1. Type of Well       Image: Second state of Well      Image: Second state of We	er		1011 101			me and No. NMO FEDERAL	7 6	
2. Name of Operator COG OPERATING, LLC	Contact: E-Mail: Abbym@bo	ABIGAIL MOI cmandassociate			9. API We 30-025	ll No. 5-31391		
3a. Address 600 W. ILLINOIS MIDLAND, TX 79701	-	3b. Phone No. Ph: 432-58	(include area code) 0-7161		10. Field a TONT	nd Pool or Explor O; YATES-7R	atory Area SOUTH

# **Conditions of Approval**

# COG Operating, LLC Geronimo, API 3002531391 T19S-R33E, Sec 31, 1980FNL & 585FWL February 27, 2018

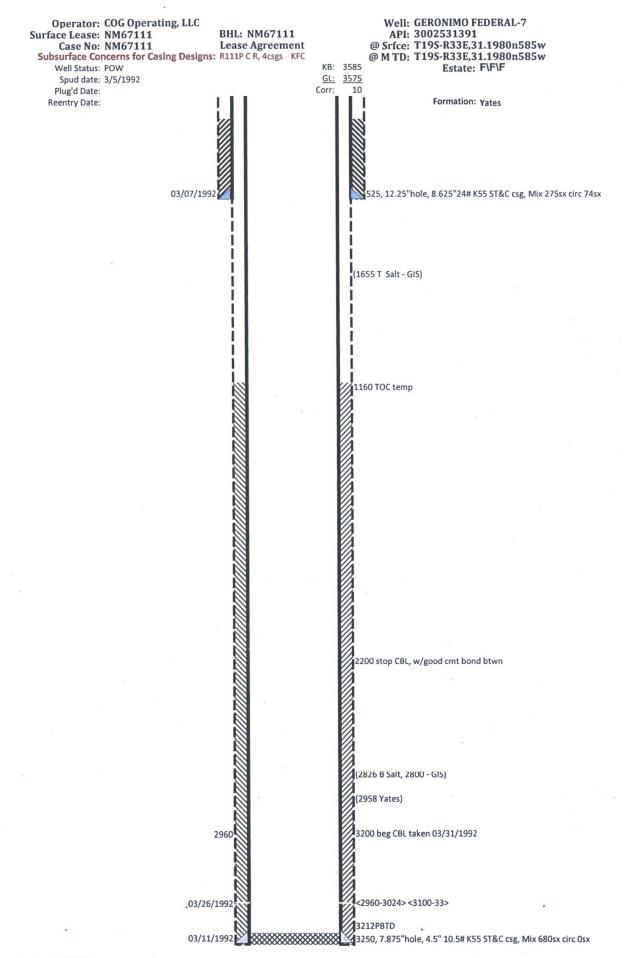
R-111-P: 3 s	trings circ, a casing sea	test of 600psi(hydrl	) for the surface and 1	1000 for intermediate, <100	Jpsi drop in
30min.	Capitan Reef: 4 casing	strings, production	cement to cover casir	ng 50 feet above Capitan R	Reef top.

Lesser Prairi	e-Unicken.				
8 5/8	surface	csg in a	12 1/4	inch hole.		Design I	Factors	SURFACE	
Segment	#/ft	Gr	ade	Coupling	Joint	Collapse	Burst	Length	Weight
"A"	24.00	K	55	ST&C	20.87	5.58	1.71	525	12,600
w/8.4#/g mu	id, 30min Sfc	Csg Test psig:	1,500	Tail Cmt	does not	circ to sfc.	Totals:	525	12,600
Compari	son of Pr	oposed to	Minimum	Required 0	Cement Vo	olumes			
Hole	Annular	Proposed	CuFt Cmt	Min	Excess	Drilling	Calc	Req'd	Min Dist
Size	Volume	Sx Cmt	Proposed	Cu Ft	% Cmt	Mud Wt	MASP	BOPE	Hole-Cplg
12 1/4	0.4127	275	433	232	86	9.00	1007	2M	1.31
12 1/4		210	400	LOL		5.00	1007	ZIVI	1.01
4 1/2	11 10107 10 10107 17 10	uside the	1 2007 A 1007 I 2007	casing.	-	Design Fac			Casing
ur nadar ur under ur nadar ur under ur ender ur nadar	11 10107 10 10107 17 10	iside the	1 2007 A 1007 I 2007	1221 - 222 - 222 - 222 - 223 17 1221 - 22 1222 - 21 1222 2 1222 - 222 1223 - 2222 - 22	Joint	1999,2000,2000,2000,2000,2000,2000,2000,			-

4 1/2	casing in	iside the Gr	8 5/8	casing.	11° 2022 11° 2024 11° 20 11° 2021 11° 2021 11° 202	<u>Ďesign Fa</u>	<u>ctors</u>	2nd (	Casing
4 1/2 Segment "A"	casing in #/ft 10.50	iside the Gr	8 5/8 ade 55	casing. Coupling	Joint	<u>Design Fac</u> Collapse	<u>ctors</u> Burst	2nd ( Length	Casing Weight
<b>4 1/2</b> Segment "A" w/8.4#/g mu	casing in #/ft 10.50 ud, 30min Sfc	iside the Gr K Csg Test psig:	8 5/8 ade 55	casing. Coupling ST&C	Joint	<u>Design Fac</u> Collapse	ctors Burst 2.78 Totals:	2nd 0 Length 3,250	Casing Weight 34,125
<b>4 1/2</b> Segment "A" w/8.4#/g mu	casing in #/ft 10.50 ud, 30min Sfc	iside the Gr K Csg Test psig: ie(s) propo	8 5/8 rade 55 1,500	casing. Coupling ST&C hieve a top	Joint 4.28	Design Fac Collapse 2.33	ctors Burst 2.78 Totals:	2nd 0 Length 3,250	Casing Weight 34,125
4 1/2 Segment "A" w/8.4#/g mu <u>The cen</u>	casing in #/ft 10.50 ud, 30min Sfc nent volum	iside the Gr K Csg Test psig: ie(s) propo	8 5/8 rade 55 1,500 esed may ac	casing. Coupling ST&C hieve a top Min	<b>Joint</b> 4.28 <u>0</u>	Design Fac Collapse 2.33	ctors Burst 2.78 Totals: surface.	<b>2nd 6</b> <b>Length</b> 3,250 3,250	Casing Weigh 34,125 34,125

- 18. Pressure test the casing to 500psig after a CIBP is set within 100ft of the top perf of 2960'.
- 19. Run a CBL at 0psig from the CIBP set within 100' of top perf 2973' and determine TOC behind the 4 <sup>1</sup>/<sub>2</sub>" production csg.

- 20. Set a min 30sx balanced "C" cmt plug on the CIBP set above top perf 2960'. WOC, and tag the plug with tbg at 2529' or above covering Yates formation top of 2958'and Base of Salt at 2826'.

- 22. Set a estimated 95sx balanced "C" cmt plug in the 4 ½" from the Base of Salt tbg tag to about 1110' or 50' below the TOC as determined by Step 19. CBL. WOC, and tag the plug with tbg.

- 23. A: Cut and pull the 4 1/2" csg from the CBL TOC & place a balanced "C" cmt plug from 50' inside the 4 ½" stub to 1560' or above.

**B:** OR perforate the 4 1/2" csg just above TOC, open the 8 5/8" csg vent and establish circulation. Sqz "C" cmt behind the 4 ½" csg to 1560' or above across the Top of Salt. Displace cement slurry in the csg to 1570' or above. Close the tbg valve behind displacement volume and hold the slurry in place. WOC, and tag the plug with tbg at 1570' or above. Report cmt volume, pkr setting and displacement volume.

24. A: The 4 1/2" csg been pulled - set a balanced 30sx "C" cmt plug from 600' or below. WOC, and tag the plug with tbg at 470' or above.

**B:** OR perforate the 4 1/2" csg at 600', open the 8 5/8" csg vent and establish circulation. Sqz min 35sx "C" cmt behind the 4 ½" csg to 470' or above across the 8 5/8" Shoe. Displace cement slurry in the csg to 470'. Close the tbg valve behind displacement volume and hold the slurry in place. WOC, and tag the plug with tbg at 470' or above.

- 25. Perf at 60' or below. Establish circulation through the 5 1/2" x 8 5/8" annulus. Fill with (±20sx) balanced "C" cmt plug and verify the 5 1/2" x 8 5/8" annulus and 8 5/8" csg from 60' cemented to surface.
- 26. File **subsequent sundry** Form 3160-**5** within 30 days of workover procedures. Include (dated daily) descriptions of the well work, i.e. procedure descriptions and setting depths of each plug in the subsequent sundry.
